The Commission has issued the enclosed Amendment Nos. 39, 37, 48 and 47 for the Dresden Station Units Nos. 2 and 3 and Quad Cities Station Units Nos. 1 and 2, respectively, in response to your requests of September 10, 1974 and May 17, 1976, as supplemented March 21, 1977 and March 13, 1978.

The amendments revise Technical Specifications to provide operating temperature and pressure limits in accordance with Appendix G, 10 CFR Part 50.

Amendment No. 39  
License No. DPR-19

SAFETY EVALUATION BY THE OFFICE OF NUCLEAR REACTOR REGULATION

Minimum Temperature Requirements per Appendix G of 10 CFR 50

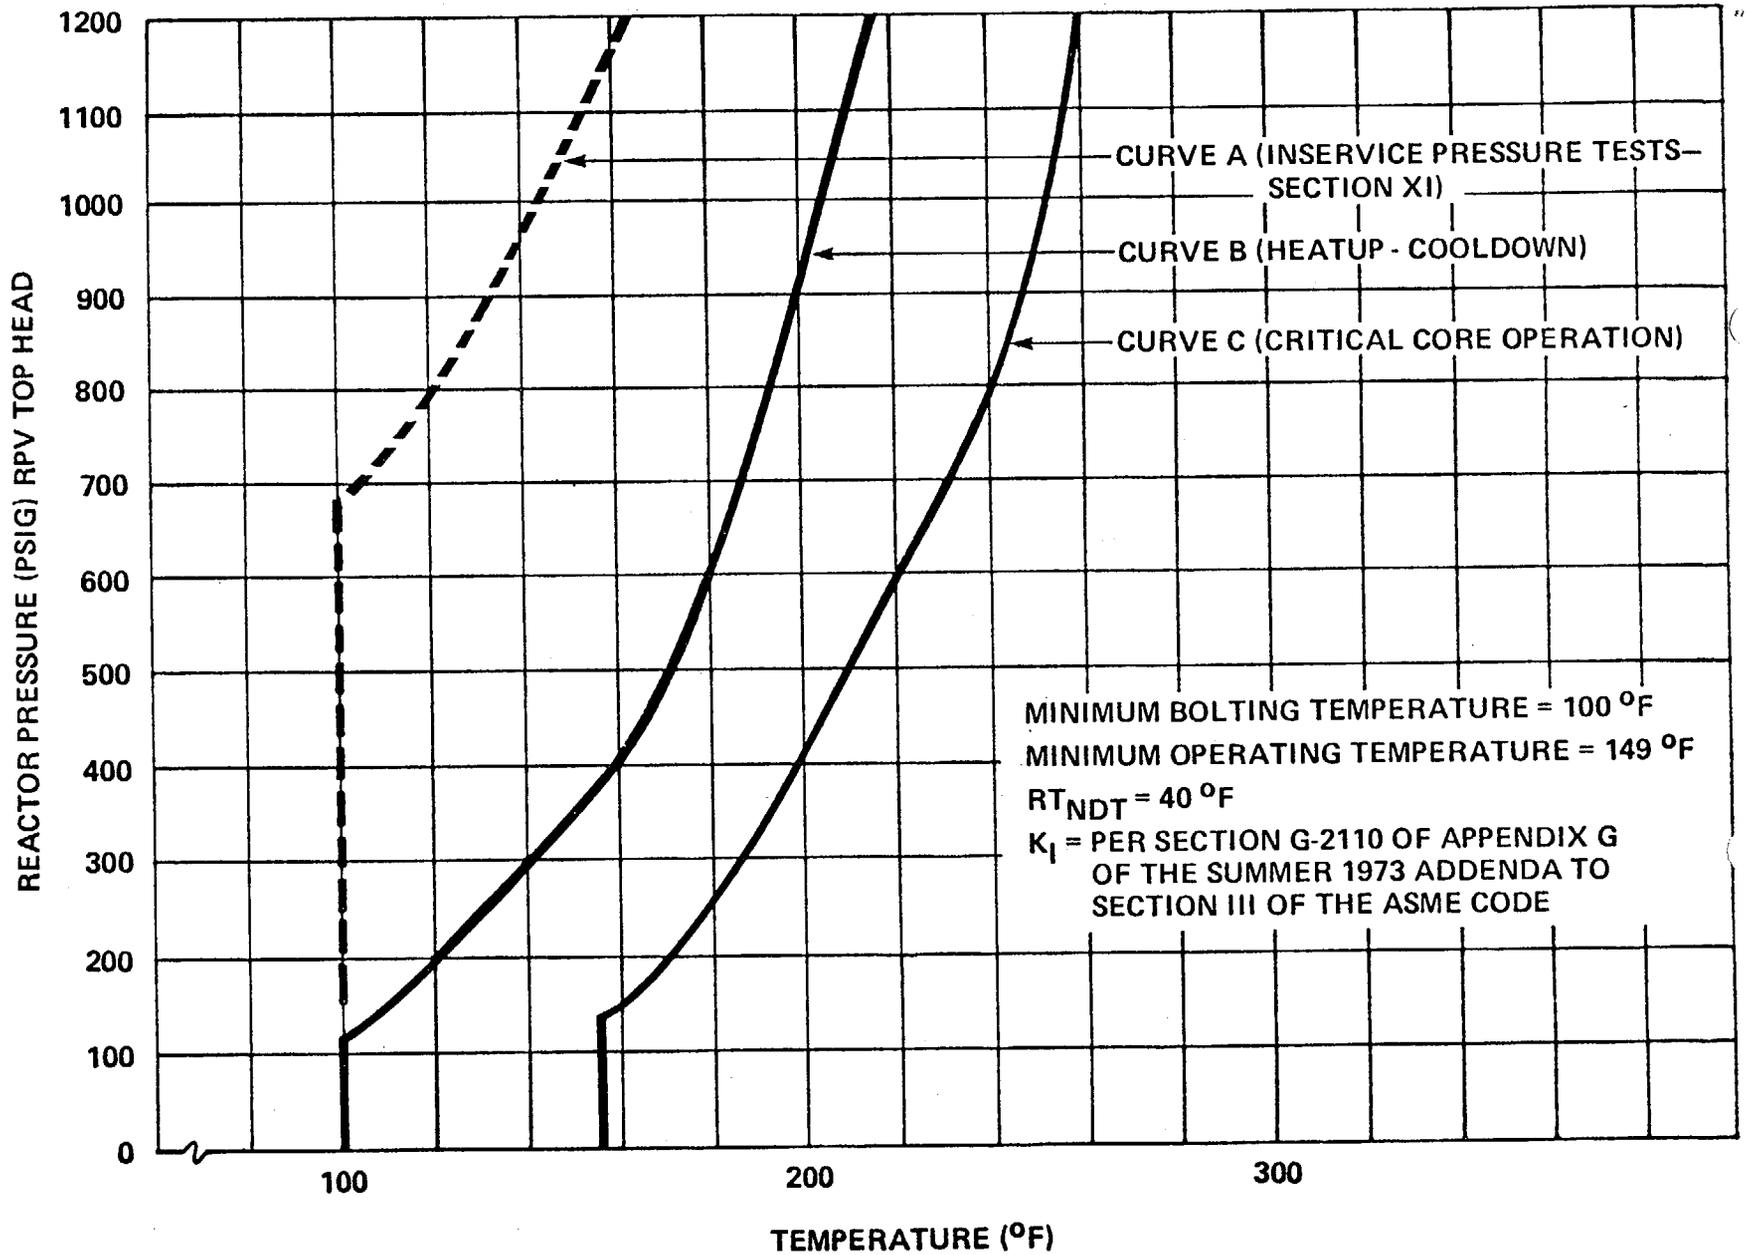
1. The reactor vessel shall be vented and power operation shall not be conducted unless the reactor vessel temperature is equal to or greater than that shown in Curve C of Figure 3.6.1. Operation for hydrostatic or leakage tests, during heatup or cooldown, and with the core critical shall be conducted only when vessel temperature is equal to or above that shown in the appropriate curve of Fig. 3.6.1. Figure 3.6.1 is effective through 6 effective full power years. At least six months prior to 6 effective full power years new curves will be submitted.
2. The reactor vessel head bolting studs shall not be under tension unless the temperature of the vessel shell immediately below the vessel flange is  $\geq 100^{\circ}\text{F}$ .

Pressurization Temperature - The reactor coolant system is a primary barrier against the release of fission products to the environs. In order to provide assurance that this barrier is maintained at a high degree of integrity, restrictions have been placed on the operating conditions to which it can be subjected. These restrictions on inservice hydrostatic testing, on heatup and cooldown, and on critical core operation shown in Figure 3.6.1, were established to be in conformance with Appendix G to 10 CFR 50.

Minimum Temperature Requirements per Appendix G of 10 CFR 50

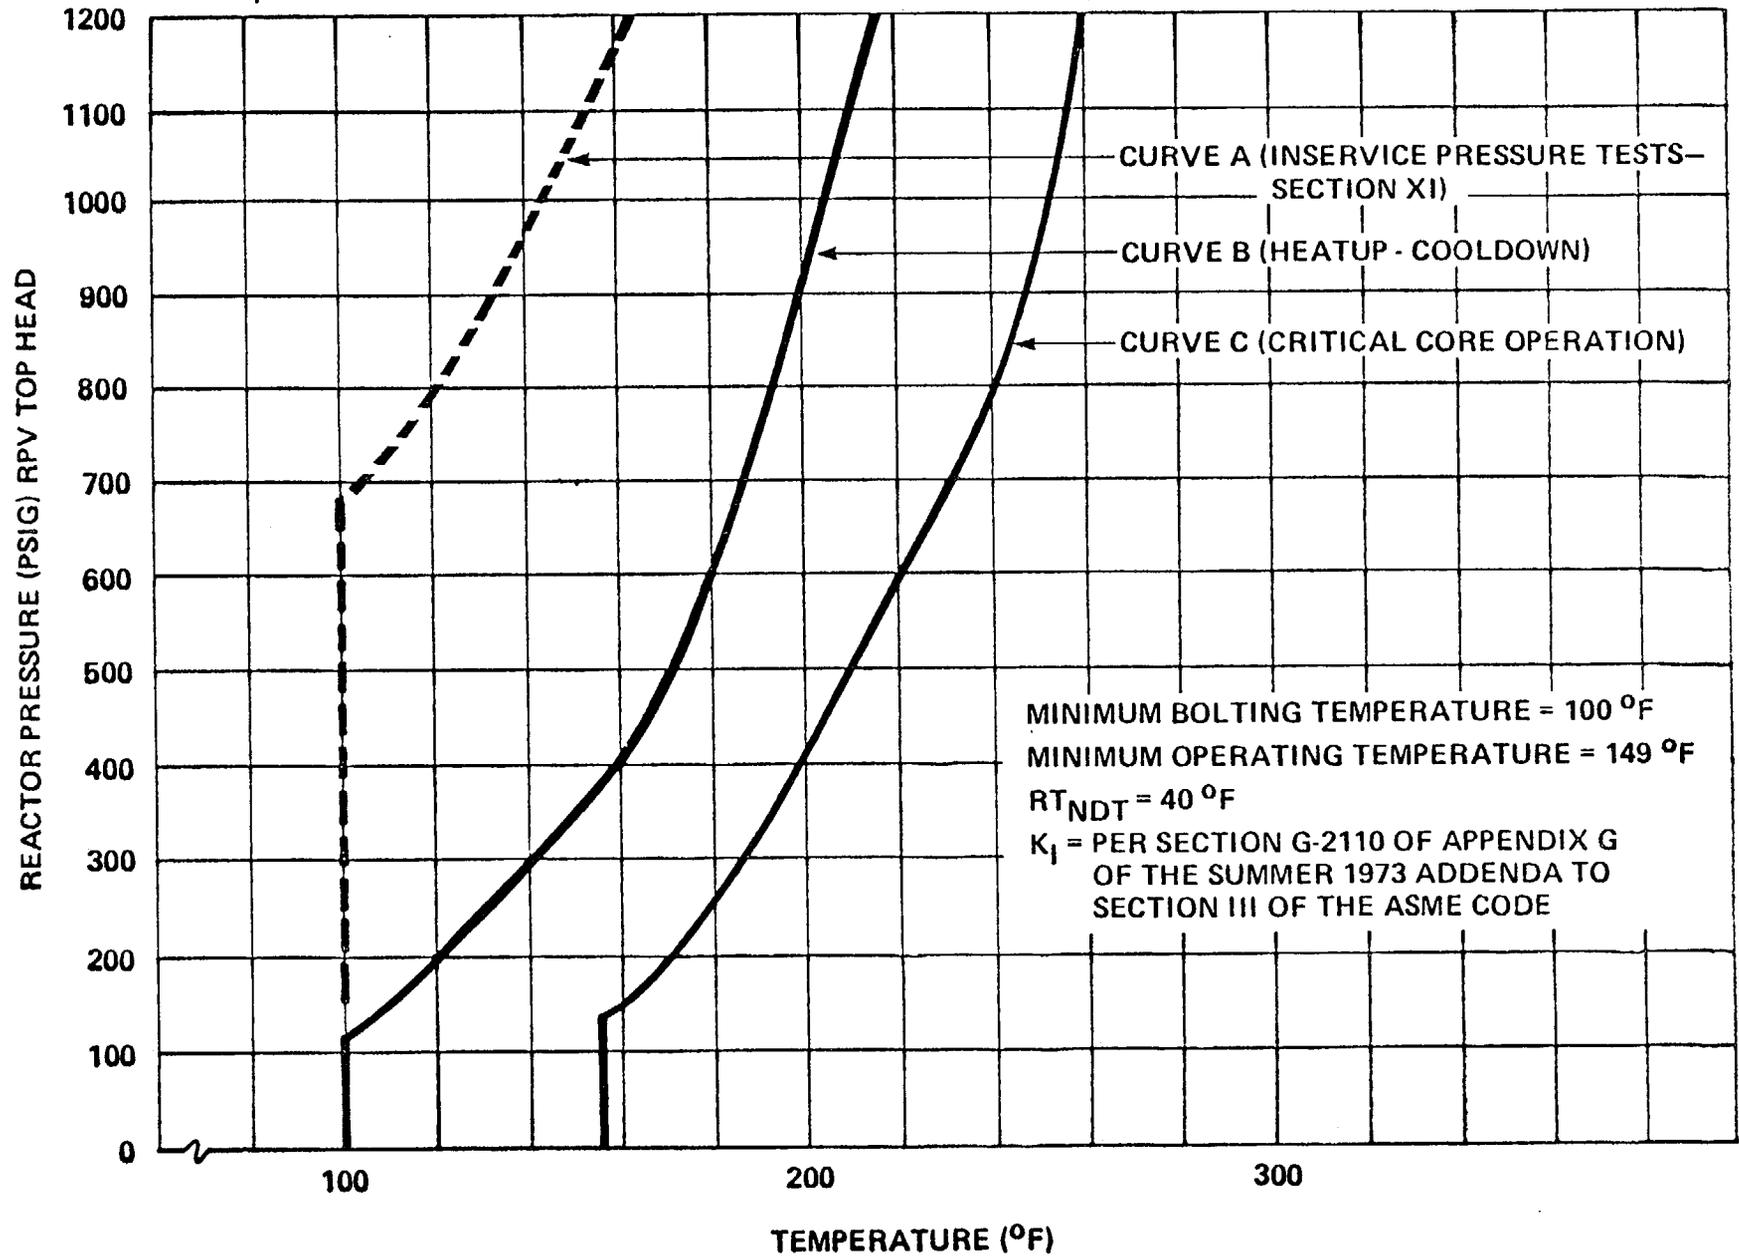
1. The reactor vessel shall be vented and power operation shall not be conducted unless the reactor vessel temperature is equal to or greater than that shown in Curve C of Figure 3.6.1. Operation for hydrostatic or leakage tests, during heatup or cooldown, and with the core critical shall be conducted only when vessel temperature is equal to or above that shown in the appropriate curve of Fig. 3.6.1. Figure 3.6.1 is effective through 6 effective full power years. At least six months prior to 6 effective full power years new curves will be submitted.
2. The reactor vessel head bolting studs shall not be under tension unless the temperature of the vessel shell immediately below the vessel flange is  $\geq 100^{\circ}\text{F}$ .

Pressurization Temperature - The reactor coolant system is a primary barrier against the release of fission products to the environs. In order to provide assurance that this barrier is maintained at a high degree of integrity, restrictions have been placed on the operating conditions to which it can be subjected. These restrictions on inservice hydrostatic testing, on heatup and cooldown, and on critical core operation shown in Figure 3.6.1, were established to be in conformance with Appendix G to 10 CFR 50.

Fig. 3.6.1

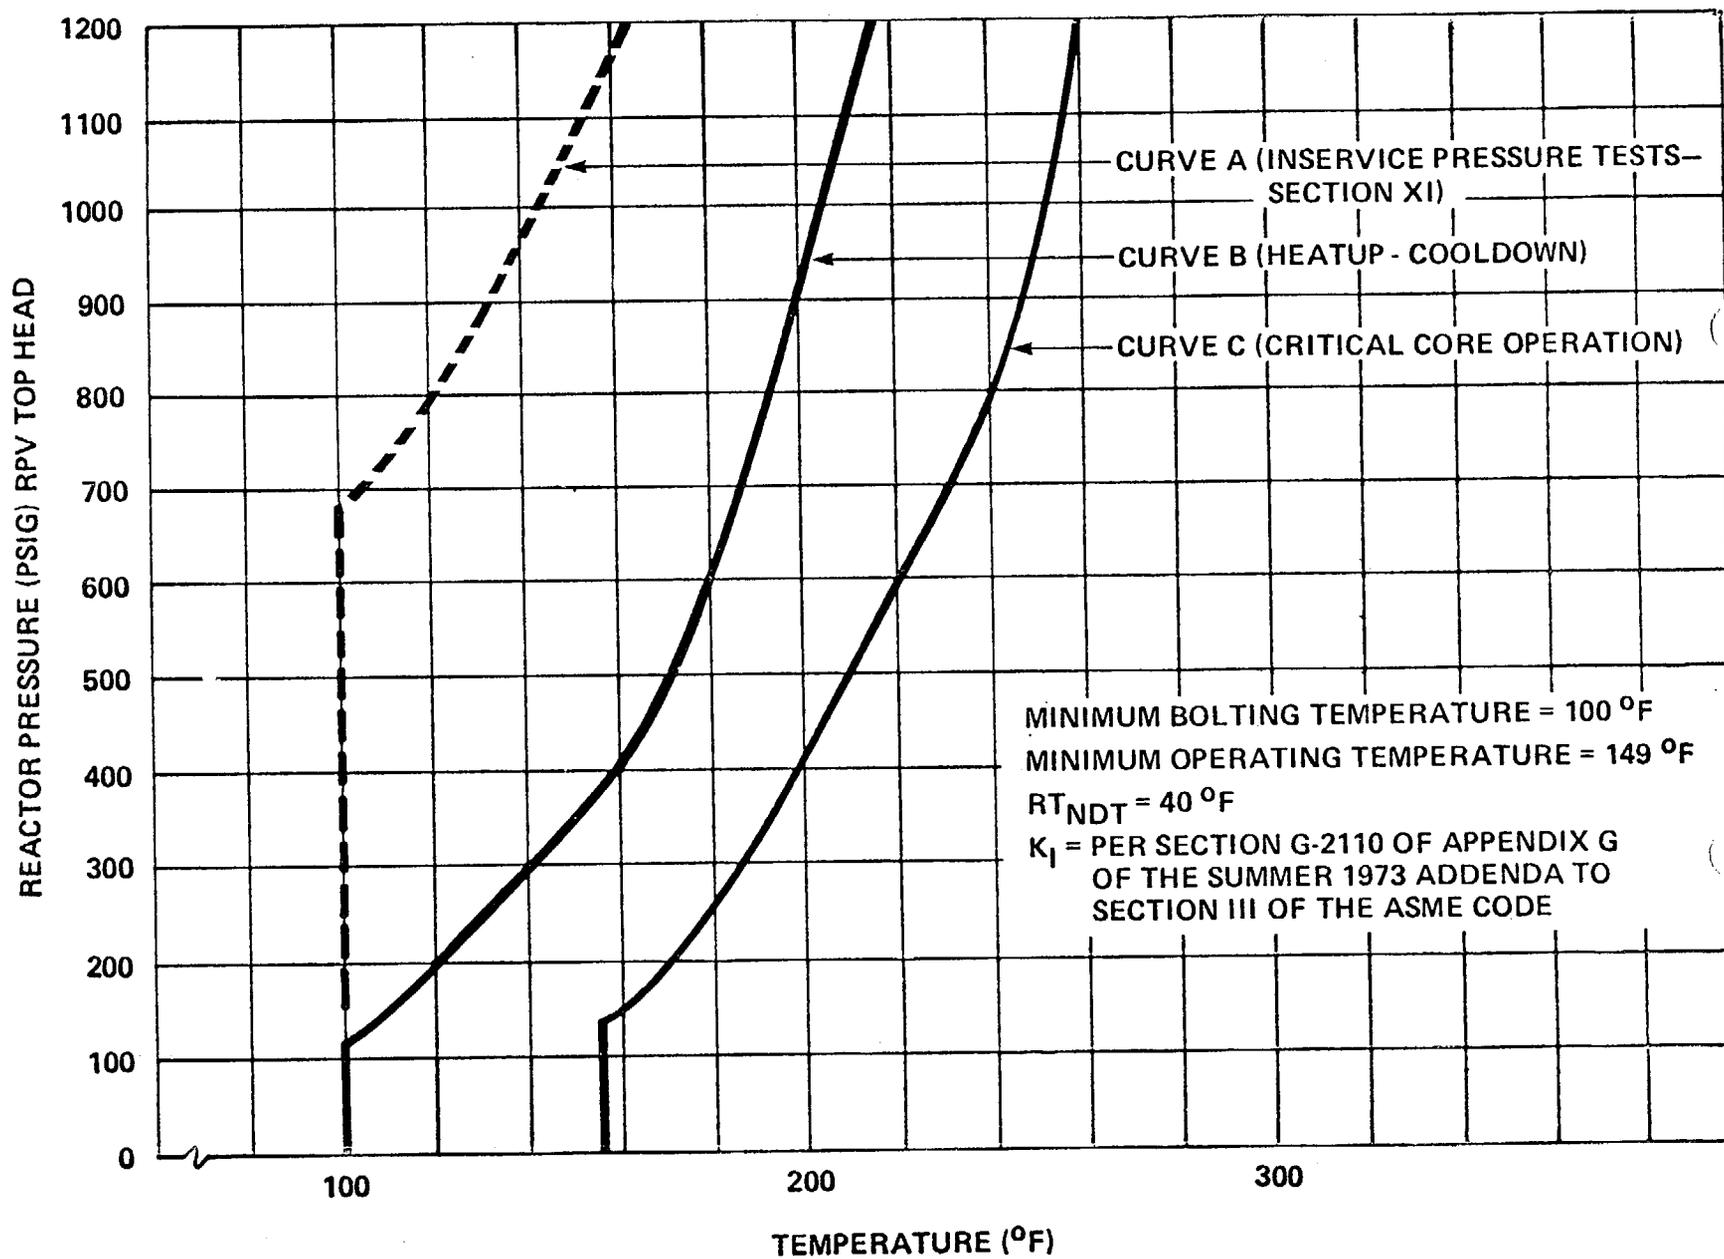
Operation for hydrostatic or leakage tests, during heatup or cooldown, and with the core critical shall be conducted only when vessel temperature is equal to or above that shown in the appropriate curve of Fig. 3.6.1. Figure 3.6.1 is effective through 6 EFPY. At least six months prior to 6 EFPY new curves will be submitted.

The reactor coolant system is a primary barrier against the release of fission products to the environs. In order to provide assurance that this barrier is maintained at a high degree of integrity, restrictions have been placed on the operating conditions to which it can be subjected. These restrictions on inservice hydrostatic testing, on heatup and cooldown, and on critical core operation, shown in Figure 3.6.1, were established to be in conformance with Appendix G to 10CFR50.

Fig. 3.6.1

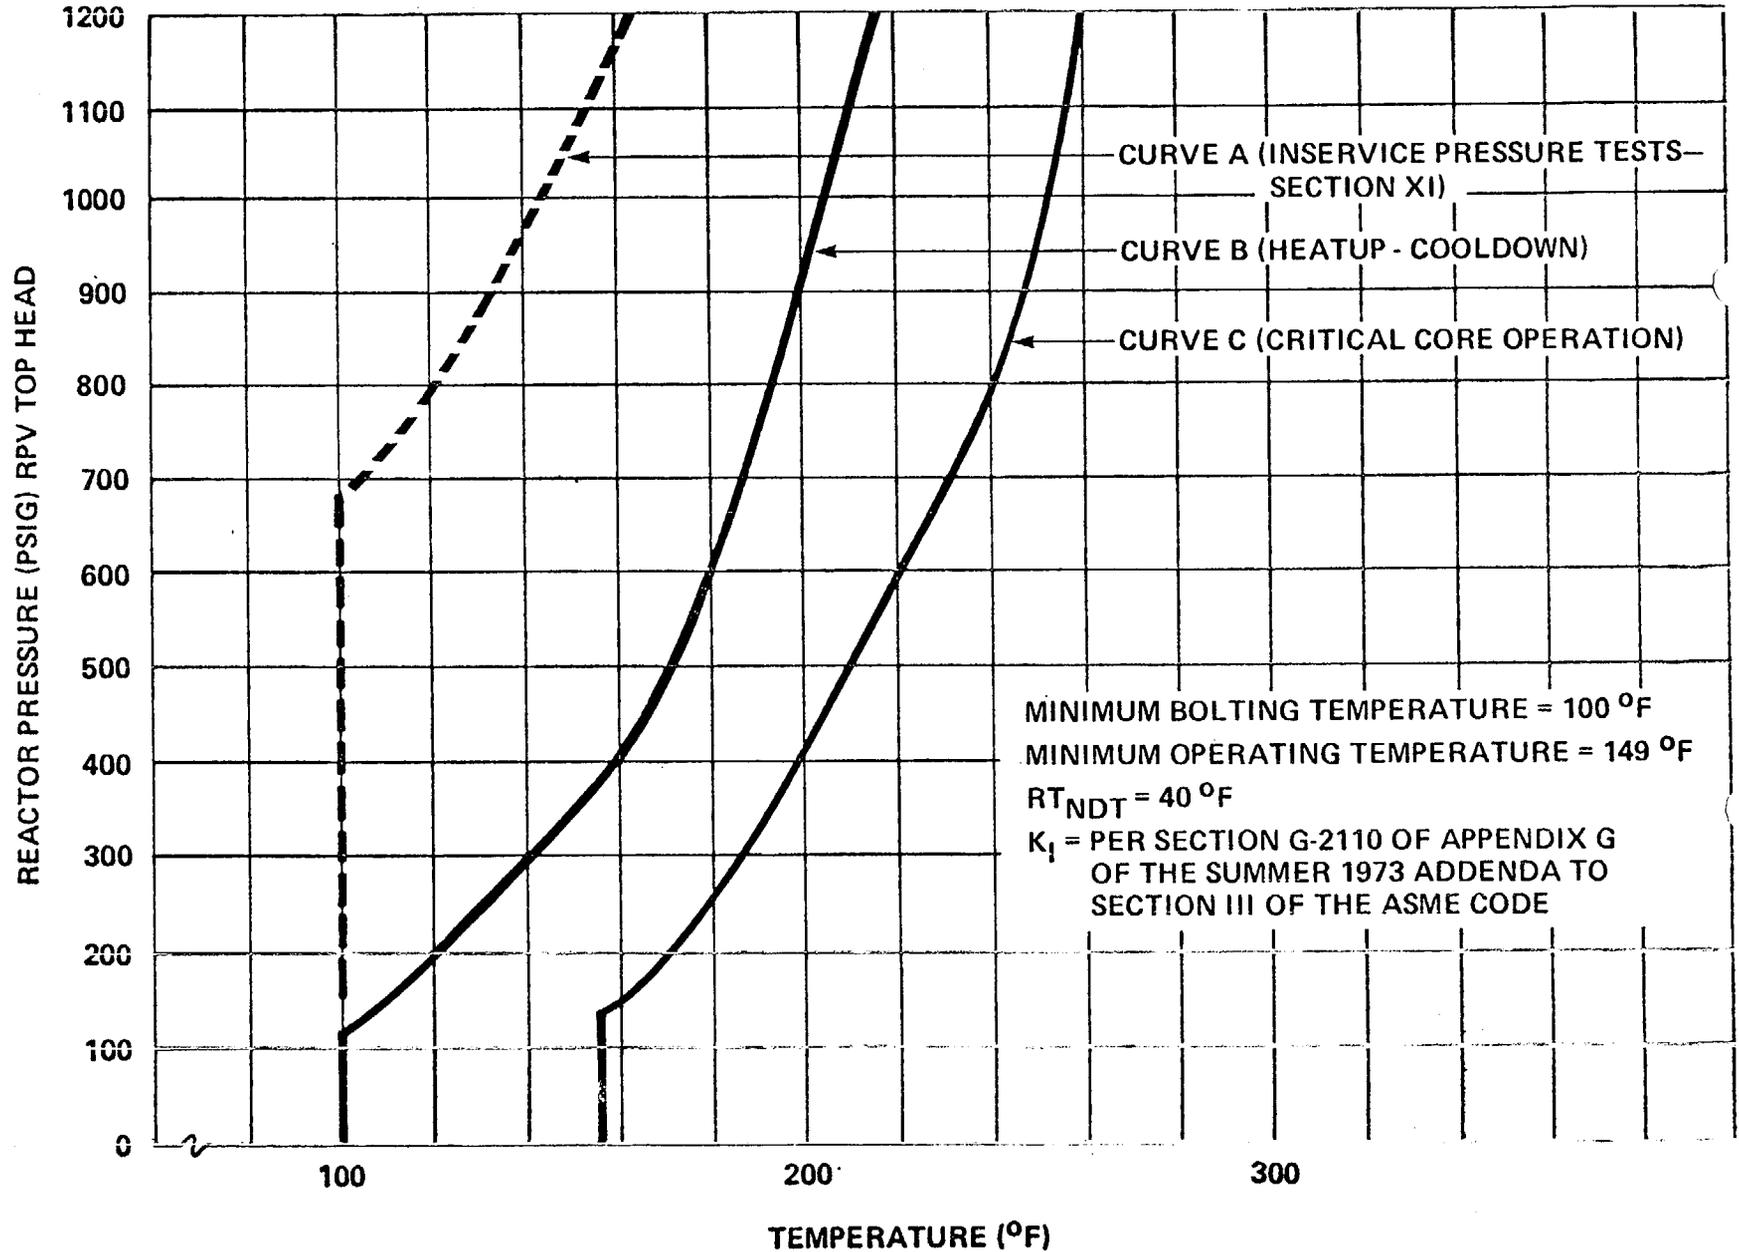
Operation for hydrostatic or leakage tests, during heatup or cooldown, and with the core critical shall be conducted only when vessel temperature is equal to or above that shown in the appropriate curve of Fig. 3.6.1. Figure 3.6.1 is effective through 6 EFPY. At least six months prior to 6 EFPY new curves will be submitted.

The reactor coolant system is a primary barrier against the release of fission products to the environs. In order to provide assurance that this barrier is maintained at a high degree of integrity, restrictions have been placed on the operating conditions to which it can be subjected. These restrictions on inservice hydrostatic testing, on heatup and cooldown, and on critical core operation, shown in Figure 3.6.1, were established to be in conformance with Appendix G to 10CFR50.
